**Resolution No. 59, “Guidelines for Waterway Signs and Markings”**

**Amendments to Resolution No. 59**

**Submitted by the International Sava River Basin Commission**

### Draft revised Resolution No. 59

**Figure 1**

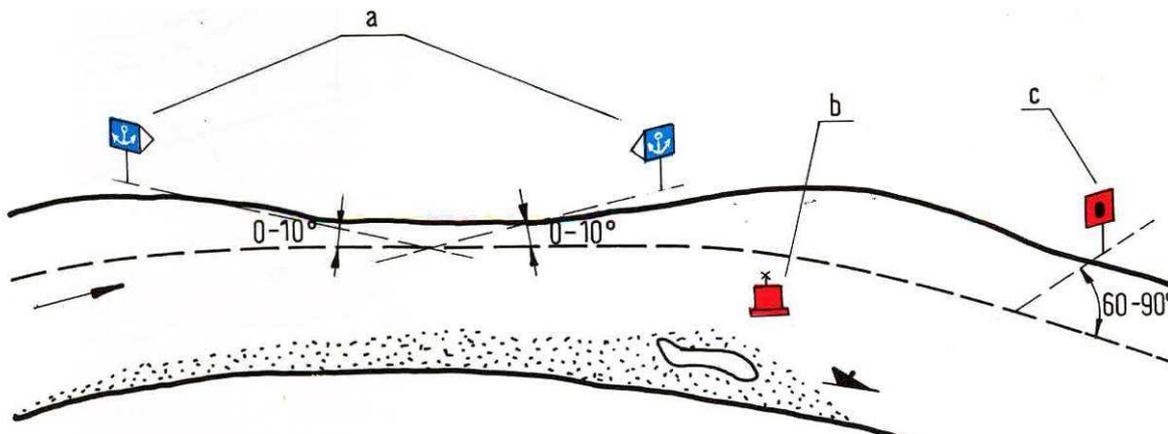
**Bank marks, which are used in two-way navigation, shall be oriented as under (a). In some cases (better visibility) angle between the mark and the axis of the fairway can be 10° or less. (Figure 1, sign a).**

**Bank marks, which are used in one-way navigation, shall be oriented as under (b). In some cases (better visibility) angle between mark and the axis of the fairway cannot be less than 60° (Figure 1, sign c).**

4.1.7 Obstacles on the sides of the fairway are always marked with signs or signals on the water. When the obstacle is indicated by a single sign, it shall be placed on the downstream extremity of the obstacle, on the channel side (Figure 1, sign b).

Figure 2

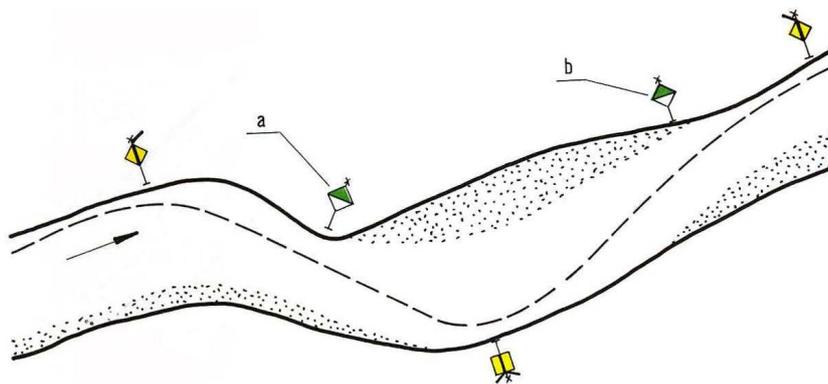
**4.2.1.4 The cross-channel fairway signs and bank lights have best results on distances up-to 3 km. On such sections cross-channel fairway signs and bank lights (without signs on the water) can be placed under conditions when the disposable width for navigation is more than two times bigger than the minimum prescribed width of the fairway for particular sector. If disposable width for navigation is less than the minimum prescribed width of the fairway for a particular sector, cross-channel fairway signs and bank lights (without signs on the water) cannot be placed on distance larger than 1–1.5 km.**

4.2.1.5 If the distance between two neighbouring cross-channel fairway signs is larger than calculated visibility, and when navigation line is passing nearby the bank, the bank lighted sign, which additionally marks the position of the navigation line, is placed between those two neighbouring cross-channel fairway signs (Figure 2, sign a). The bank lighted sign is also placed when the fairway passes near the bank (Figure 2, sign b).

Figure 3

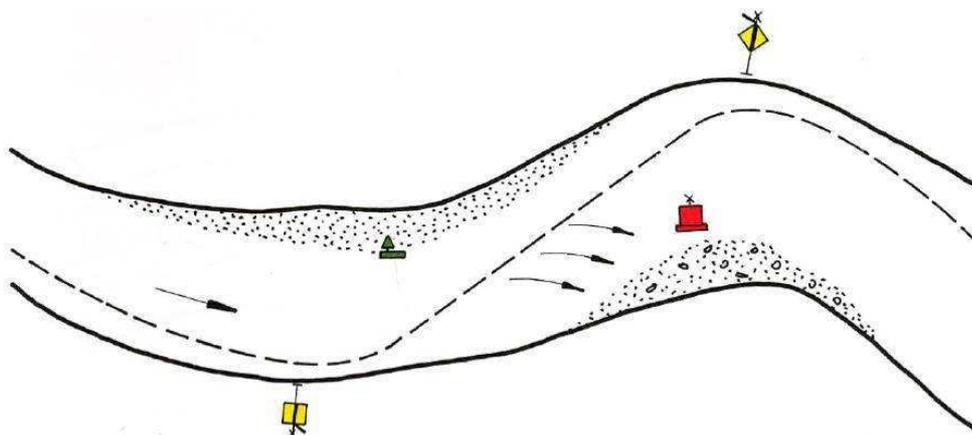
4.2.1.6 In case when the direction of the current makes the angle with fairway, when strong side winds or something alike occurs, fairway can be additionally marked by navigation marks according to the local conditions (Figure 3).

Figure 4

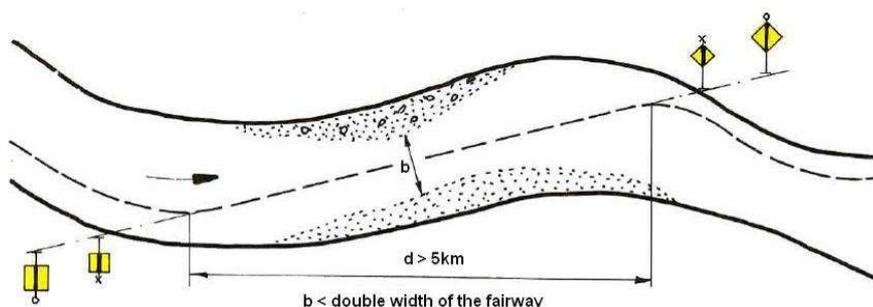
4.2.1.7 If the fairway at longer transitions goes through the river centre or stingingly crosses from one to another bank, then two cross-channel fairway signs on each side of the fairway, which better mark the transition, can be placed as shown on Figure 4.

The advantage is given to two cross-channel fairway signs on each side of the fairway in case of straight-line sections longer than 5 km, where disposable width for navigation is less than double width of the minimum prescribed width of the fairway for particular sector. In that case and when the bank configuration allows so, the cross-channel fairway signs are placed on both margins of transition (Figure 4).

Two cross-channel fairway signs on each side of the fairway are also placed when certain obstacles to navigation or other hazards narrowing the fairway occur.

Figure 5

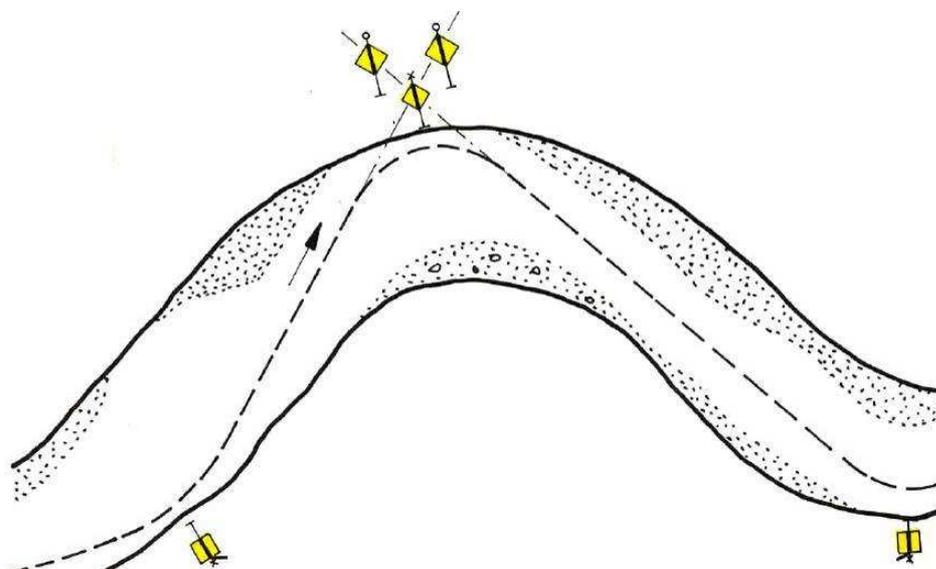
4.2.1.8 On section where the navigation line re-crosses to the opposite bank immediately after transition to the opposite bank, three cross-channel fairway signs (the front should have two boards) are mandatory placed (Figure 5). In that case, lights of the back cross-channel fairway signs should be strictly directed to the fairway axis: one to upstream and other one to downstream.

**Figure 6**

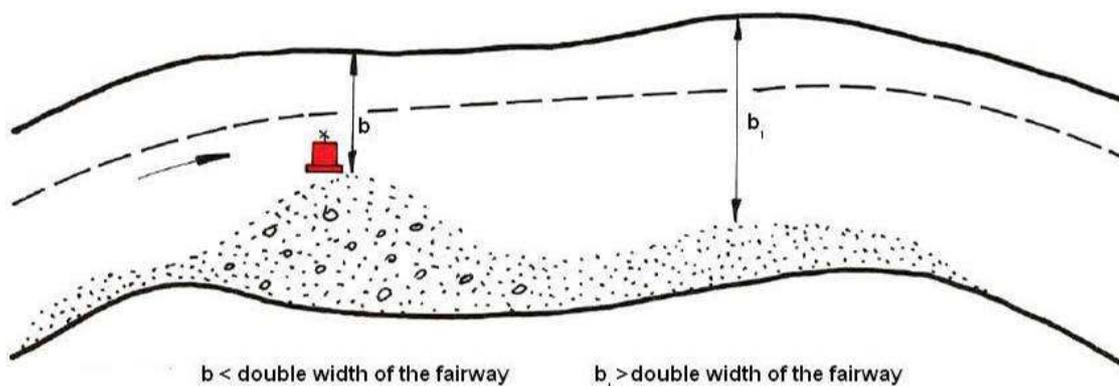
4.2.2.1 In sectors of alluvial channels, where the channel passes along the middle of the river bed, or along the bank or passes slowly from one bank to the other, signs and signals on water are used to mark formations in the river bed or obstacles, both natural and artificial, on the sides of the channel (banks, shores, islands, stones, sunken vessels, wrecks of bridges, etc.), when these obstacles protrude into the fairway and reduce its width (**Figure 6**).

Figure 7

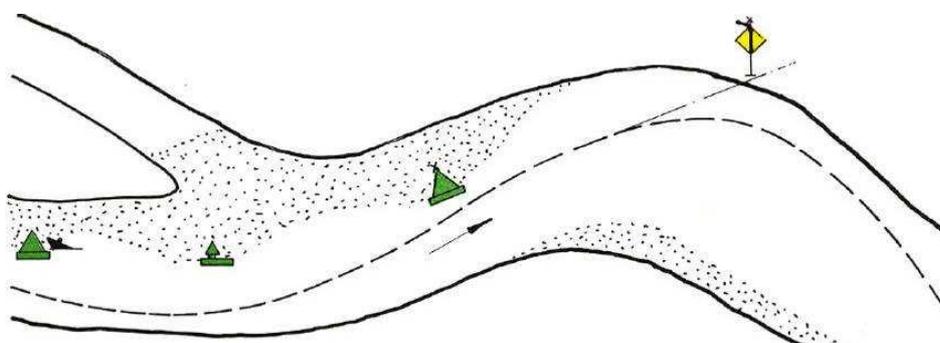
4.2.2.32 The signs and signals on the water marking underwater obstacles of considerable length are installed in such a way that the parts situated closest to the channel are marked by light signals between which unlighted signs are placed, thus enabling a given obstacle to be marked completely (Figure 7).

Figure 8

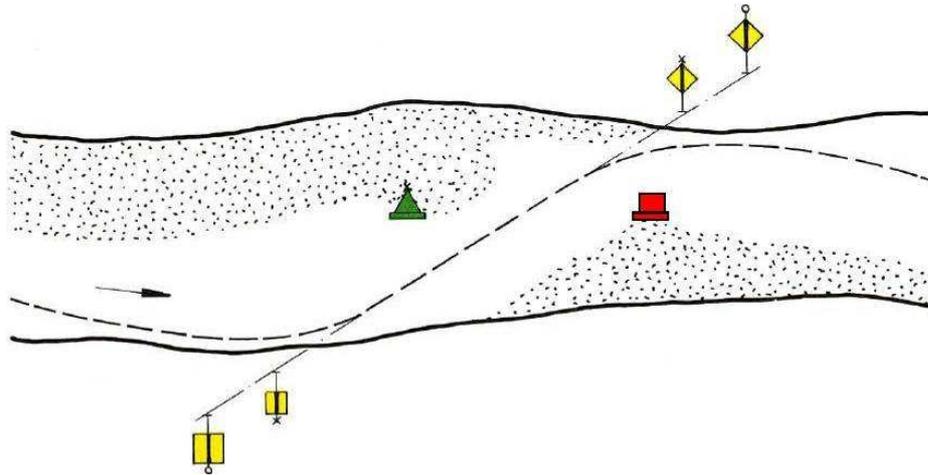
4.3.2 Alternately placed shallow water may also be marked by cross-channel fairway signs, with sufficient disposable width for navigation in which vessels are passing in straight-line (Figure 8).

Figure 9

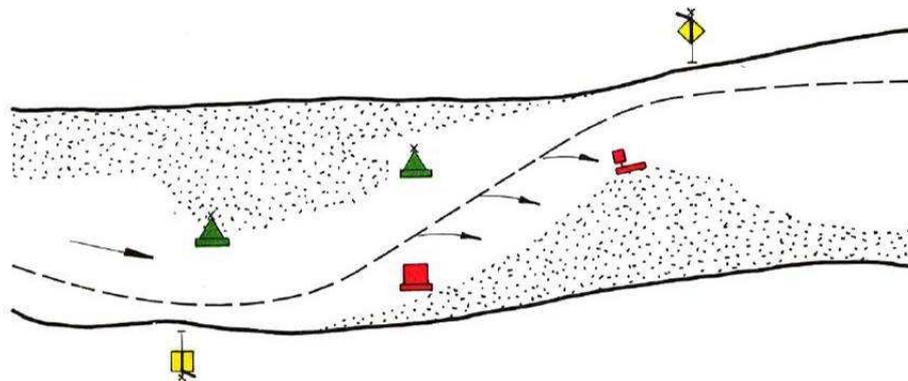
4.3.3 Fairway passing over the shallow water is usually marked by signs and signals on the water (Figures 8 and 9).

Figure 10

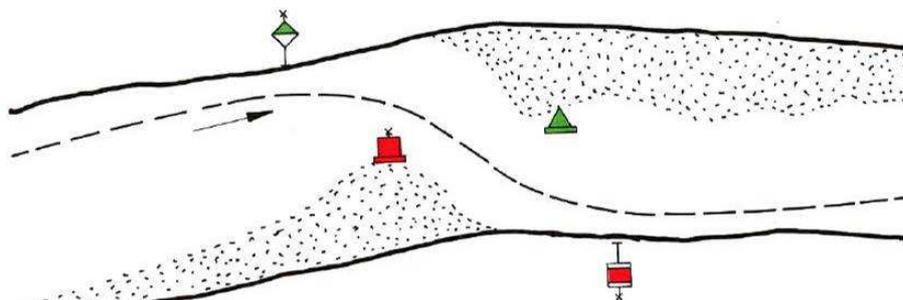
4.3.4 If the fairway is passing between sandbars, which get deeply into the riverbed, in straight-line, it is necessary to place at least two signs on the water on the entry and exit of such section: one on the top of the upstream sandbar and other one on the top of the downstream sandbar (Figure 10).

Figure 11

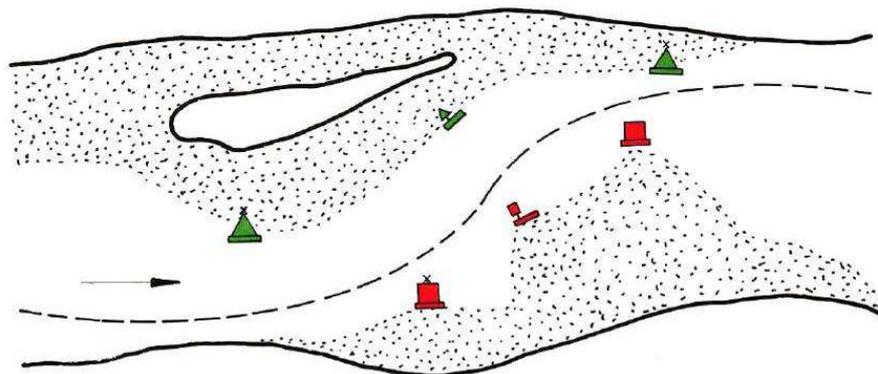
4.3.5 If the fairway is curved in the section between sandbars, it's necessary to place additional signs on the water (Figure 11).

Figure 12

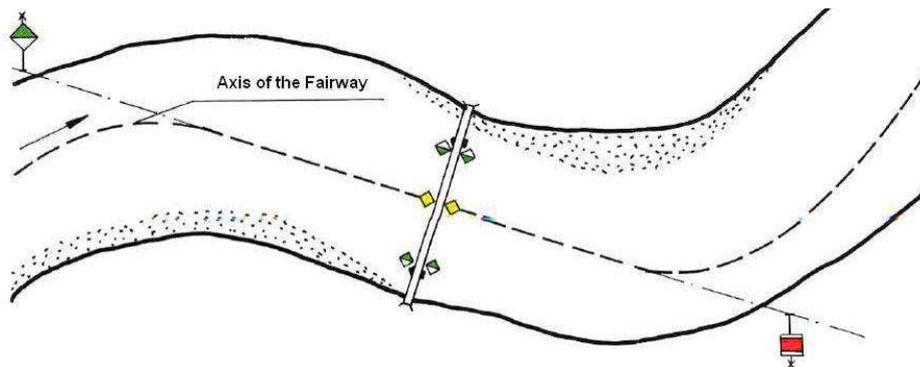
(a) If bridge is in inflexion, the direction of vessels passing through the bridge passages may be marked by signs on the water (B.1, B.2 Annex 8 to CEVNI) (Figure 12).

Figure 13

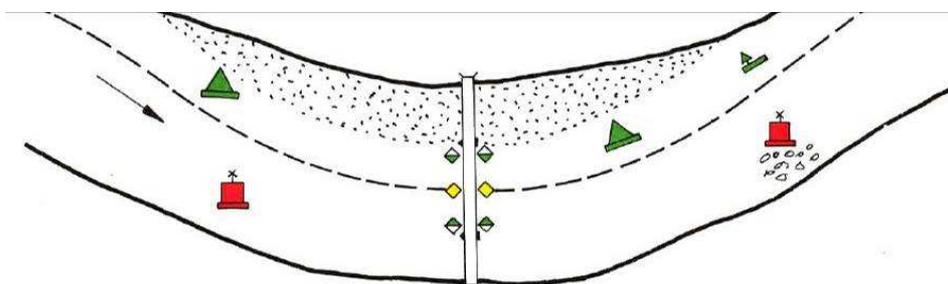
(b) If, due to larger curvature of the fairway or some other reasons, marking by the aforementioned signs is not possible, signs and signals on the water (buoys, etc.), placed in order to follow the current, may be used (Figure 13).

Figure 14

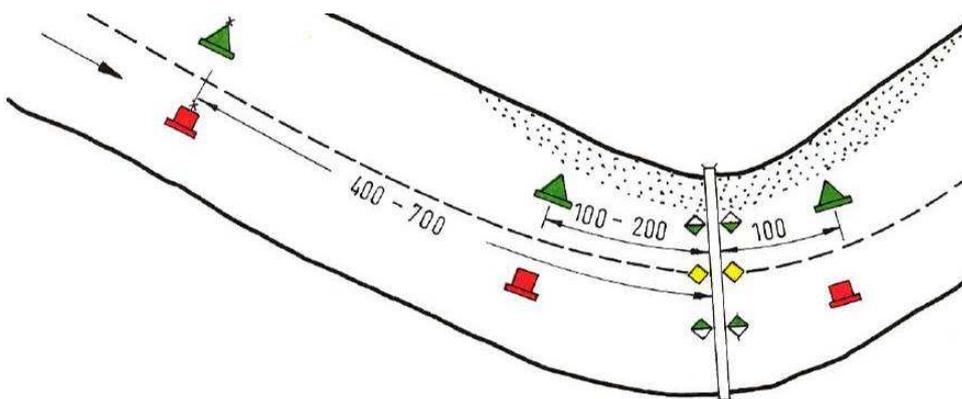
(c) If the bridge is positioned on the section where the current makes an angle with the fairway, marking may be done by two pairs of buoys upstream of the bridge. Pair of buoys closer to the bridge are placed on 100 m – 200 m distance upstream of bridge, and second pair of 400 m – 700 m upstream of bridge. Buoys more distant from the bridge are placed in order to follow the river flow jointly with the closer pair of buoys. Another pair of buoys may be placed downstream of bridge on 100 m distance from the bridge (Figure 14).
